Appendix A Water Availability Assessment

Reference: Water Availability Assessment for Carleton Place Water Treatment Plan

COMMENTS AND PROPONENT RESPONSES

Figure 1 Carleton Place Drinking Water Intake

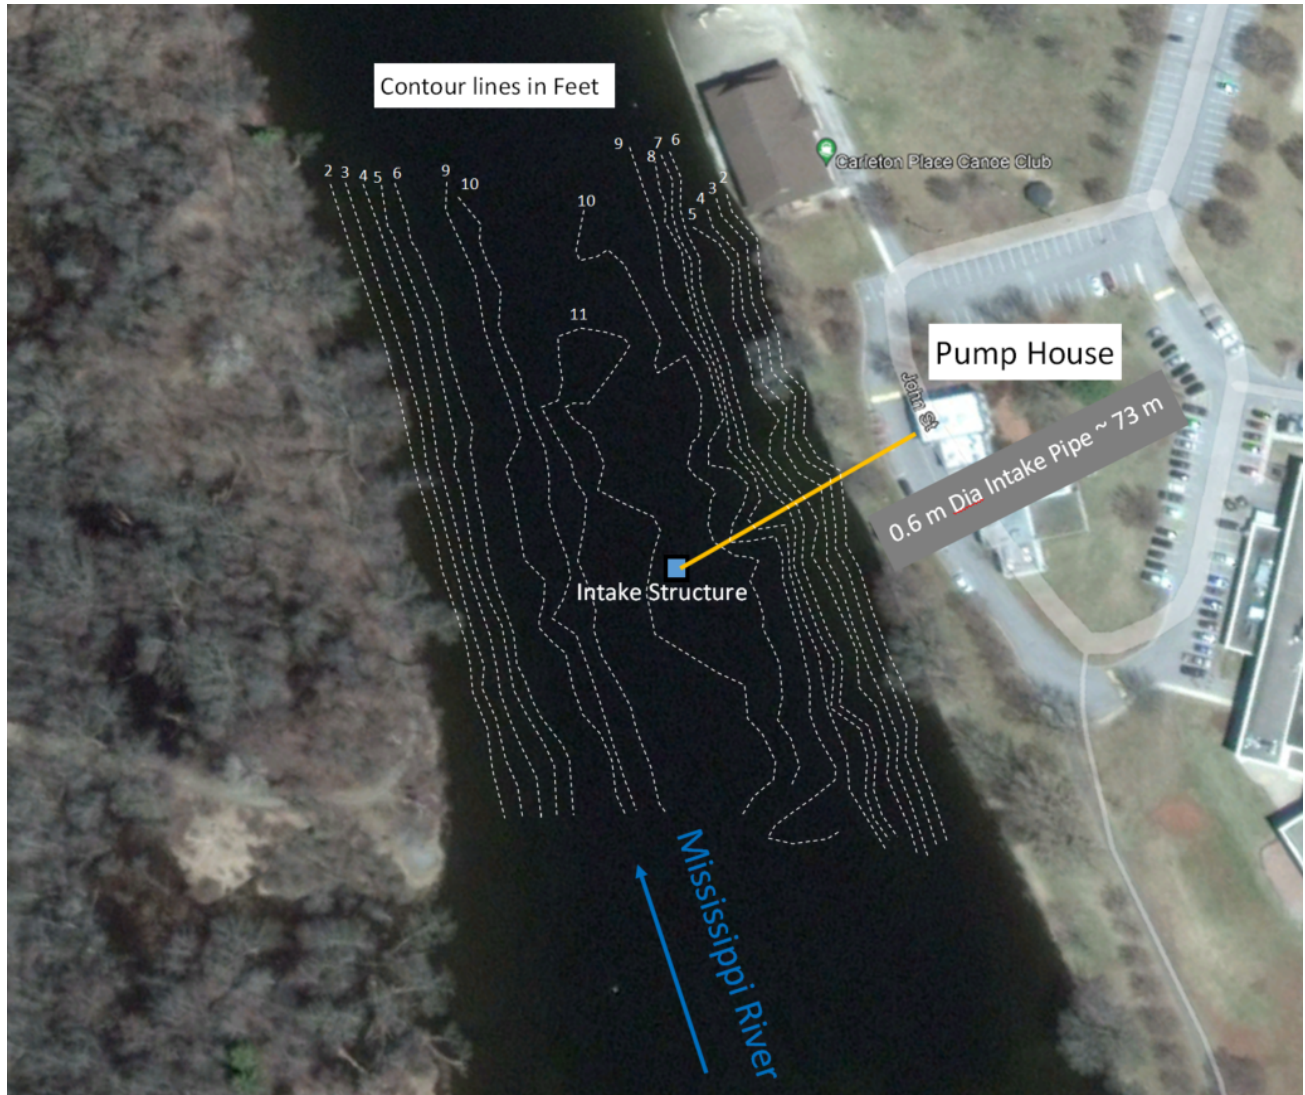
Comment No.	Item	MVCA Comments – Received May 5, 2022	Response
MVCA - 1	Introduction	<p>Report Text: The intake is located in the downstream section of Mississippi Lake.</p> <p>Comment: The intake is located in the Mississippi River</p>	Text was revised to “The intake is located in a Mississippi River reach directly connected to the downstream section of Mississippi Lake”.
MVCA-2	Mississippi Lake Hydrology	<p>Report Text: Figure 5 Historical Daily Water Levels from 2009 to 2021 in Mississippi Lake and at the Carleton Place Dam</p> <p>Comment: Only 11 years of historical data is plotted; full record shows even more pronounced decreasing trend in low lake levels.</p>	<p>13 years of historical data is plotted on Figure 5. Water level data at the Carleton Place Dam is only available from January 2009. Stantec pulled available data from the MVCA website https://mvc.on.ca/water-levels/ .</p> <p>Water level data at Mississippi Lake is available for a longer period, however, Figure 5 presents the period of records when both stations are reporting.</p>

Figure 5 Historical Daily Water Levels from 2009 to 2021 in Mississippi Lake and at the Carleton Place Dam

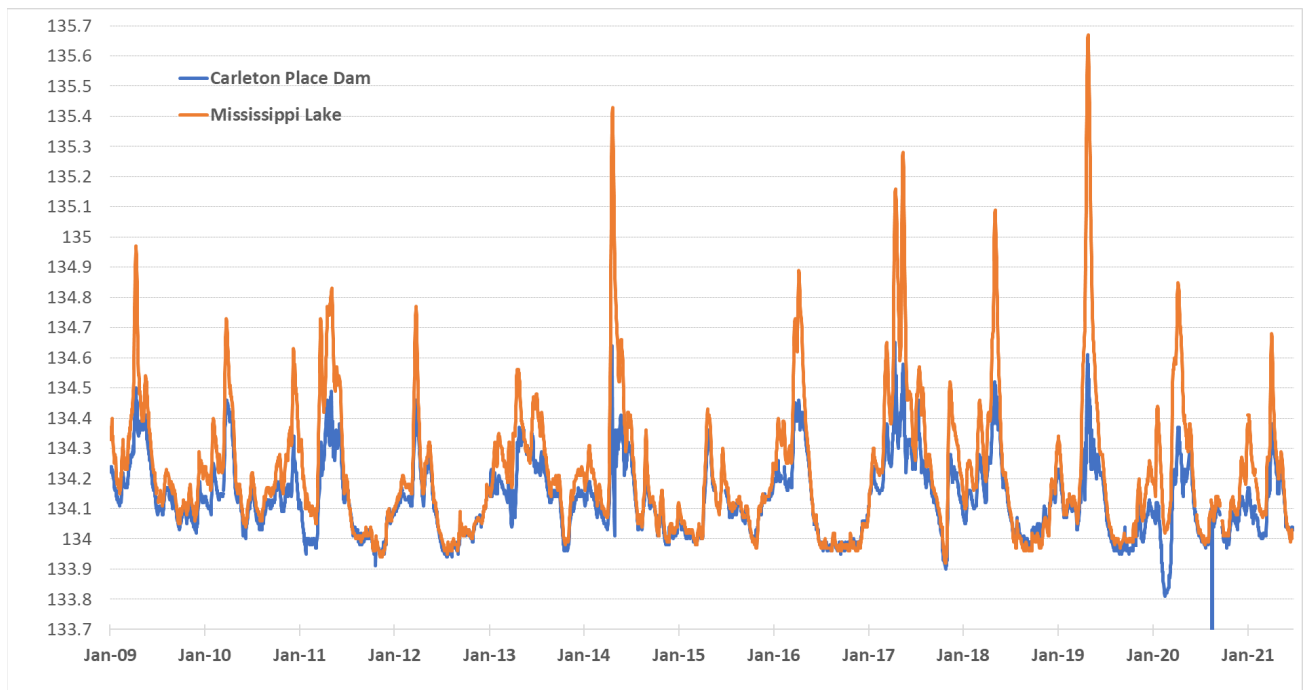
Comment No.	Item	MVCA Comments – Received July 8, 2022	Response
MVCA – 9	Mississippi Lake Hydrology	<p>Response to MVCA-2: Water level data at Mississippi Lake is available for a longer period, however, Figure 5 presents the period of records when both stations are reporting</p> <p>Comment: Why limit analysis to just when both stations have data? To assess long term trends, using a longer record from Mississippi Lake would provide a more comprehensive historical analysis.</p>	The purpose of the figure was to compare data from both stations to see how they correlate. Based on discussion in a meeting with MVCA on July 26, 2022, no further action required.
MVCA-10	Mississippi Lake Hydrology	<p>Response to MVCA-8: The water availability study did not consider the hypothetical scenario of dam failure</p> <p>Comment: The intake for the Carleton Place Water Treatment Plant is located upstream of the Carleton Place Water Control Structure. In the event of a dam failure, there</p>	Based on discussion in a meeting with MVCA on July 26, 2022, Stantec included an acknowledgement in the report that the intake is upstream of the dam and a dam failure would result in water availability issues, including exposure of the Carleton Place water treatment plant intake. The Master Plan includes mitigation measures for lack of water due to climate change. In the ESR, we will recommend that the Town update its emergency response plan in the event that river source water is not available.

Figure 6 Intake Structure

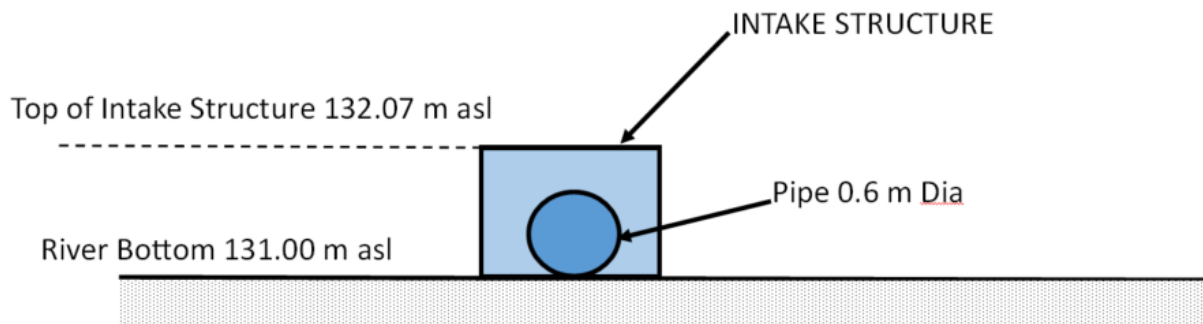
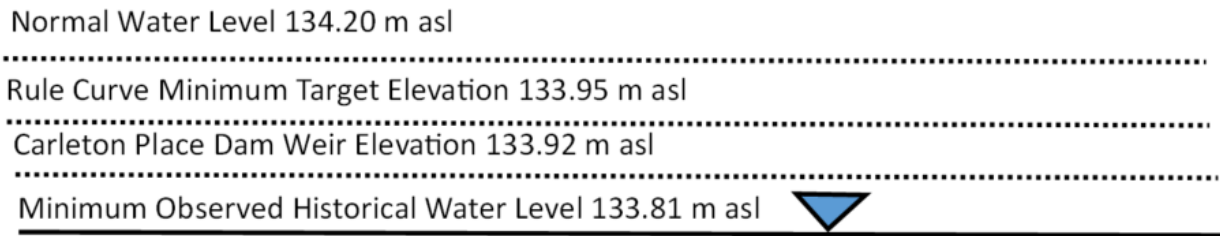
MVCA-3	Mississippi River Flows	<p>Report Text: Table 3.1</p> <p>Comment: Table not found</p>	It was a typo, reference was removed. .
MVCA-4	Discussion	<p>Report Text: Schematic intake structure is shown on Figure 6. The top of intake structure is located 1.07 m above the river bottom. The water depth at average water level is 3.72 m, and water depth during the lowest observed water level is 3.33 m. Therefore, freeboard between the top of the intake structure and the lowest historical observed water level is 2.26 m.</p> <p>Comment: MVCA bathymetric data suggests river bed elevation at water intake to be close to 131.0 masl, 0.5 m higher than Stantec data (130.5 masl). This would reduce freeboard by ~0.5 m</p>	<p>Elevation of the intake structure and bathymetry around the intake were obtained from design drawings and bathymetry maps available to Stantec. The report and figures were updated with the new bed elevation of 131 m provided by MVCA.</p> <p>Considering the new MVCA bathymetry information the freeboard will be reduced by 0.52 m from 2.26 m to 1.74 m. Freeboard of 1.74 m is still sufficient for the existing intake as a drop of water level in Mississippi Lake of 1 cm corresponds to an estimated reduction in lake volume of 234,900 m³.</p>
